Town of Parker Community Development Department  
Development Review Division  
Attention: **Julia Duncan**

Application Type: **Subdivision Plan – Replat**  
Status: **First Referral**  
Application Name: Compark Village South  
Case/AP#: **SUB21-065**  
Referral Received: October 11, 2021  
Comments Due: November 9, 2021

Review date: **November 8, 2021**  
Plan reviewer: **Randall L. Capra, [rcapra@parkeronline.org](mailto:rcapra@parkeronline.org)**  
Phone: 303.805.3168

**TOWN OF PARKER - FIRE/LIFE SAFETY:**

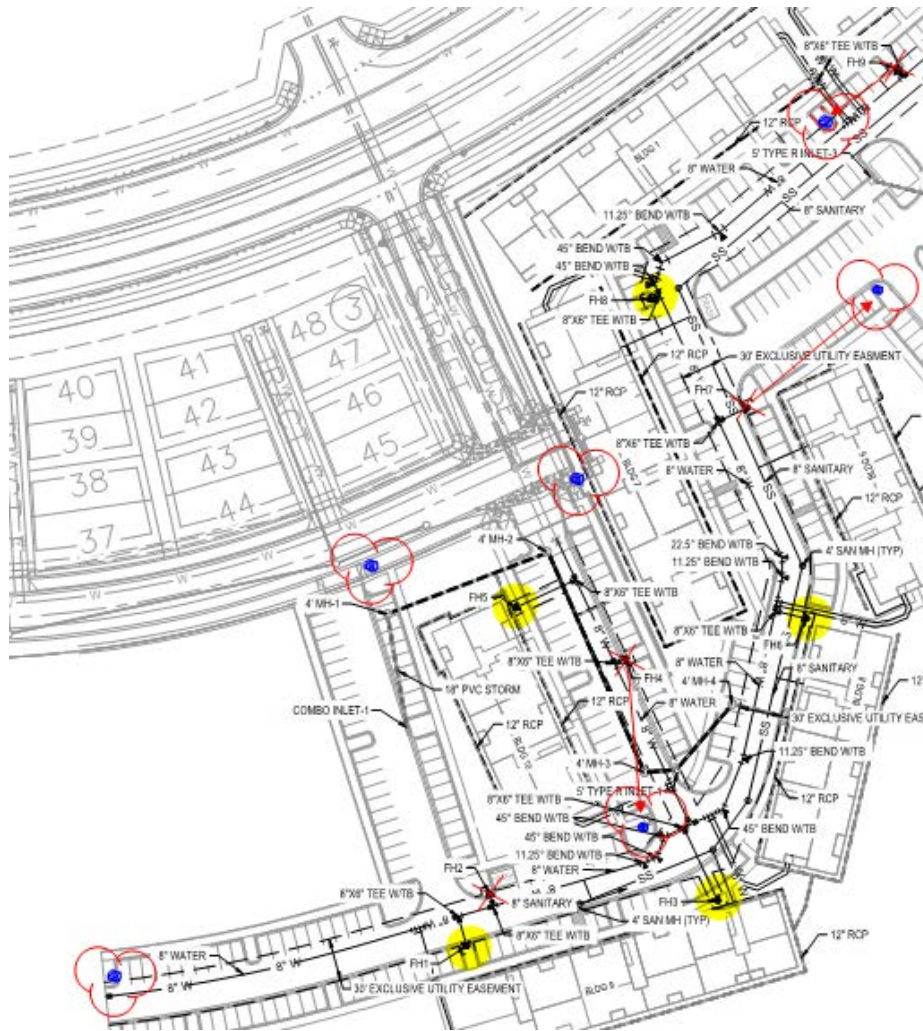
*Note – The applicant has not provided the required response to this letter with this submittal; comments will be addressed based upon information provided or noted as a red-lined requirement. Lack of acknowledgment does not exempt applicant from the responsibility of addressing all issues as required below (some comments will be acknowledged based upon the applicant's comments to SP21-118):*

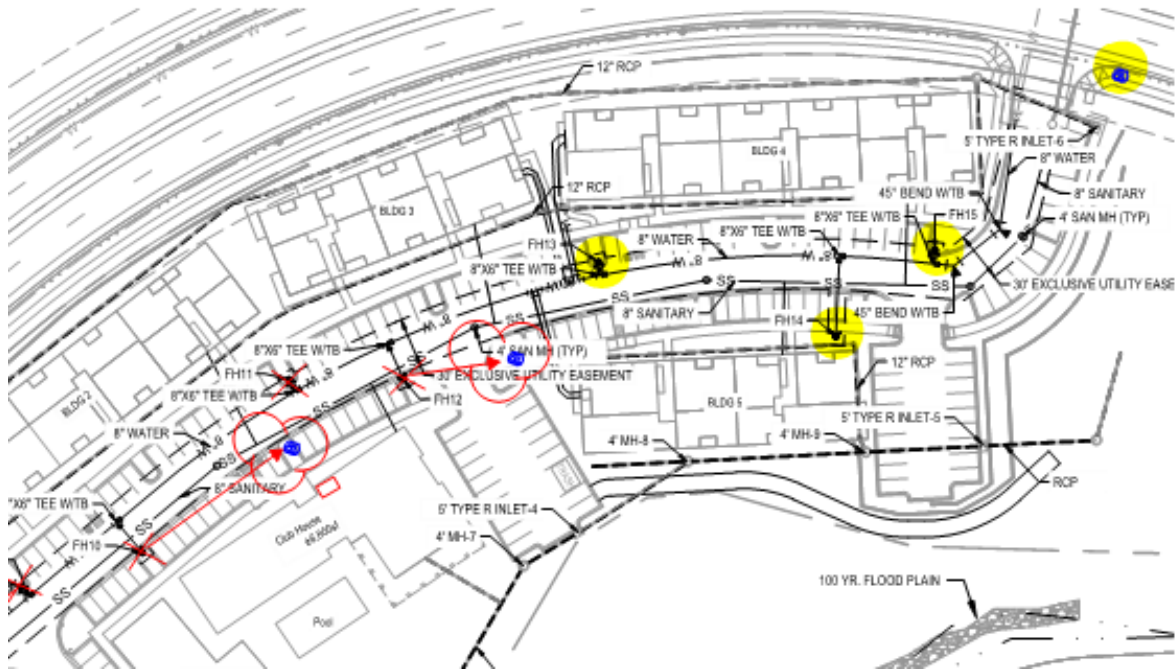
13. The hydrant distribution has been redlined to accommodate response more effectively; the overall utility drawing shall include the hydrant distribution for all filings and the following criteria. See below for information on hydrant location criteria and on revisions to the hydrant layout (hydrants have been deleted, added, and relocated while shown at entry ways if not currently addressed): *While not acknowledged specific to this application, applicant has noted/ acknowledged/addressed on the site plan submittal named SP21-118.*

- Hydrants shall be located no further than 40 feet of the building to be served.
  - Hydrants serving buildings with fire suppression systems shall be located in the general area of the riser room.

- Divided roadways require that hydrants be spaced at 250 foot intervals on a stagger (on each side of the road); these hydrants shall be located 500 feet apart on each respective side of the road.

- Hydrants shall be located at the entry into each sub area.
  - Hydrants shall be located at the end of most cul-de-sacs.
  - Hydrants shall be located at the corners of all streets where possible

- Hydrant spacing shall meet the requirements of the 2018 IFC Chapter 5 and appendix B and C
